TELEVISION TECHNICAL BULLETIN

MODELS 51CS03H 59CS03H 66CS03H

Points to resolder on L501

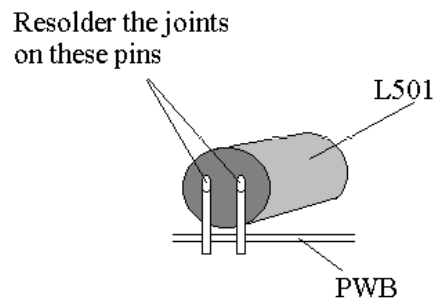
SYMPTOM No or intermittent vertical output.

CAUSE Intermittent solder joint on L501.

ACTION Resolder joint on L501 as shown in the diagram below.
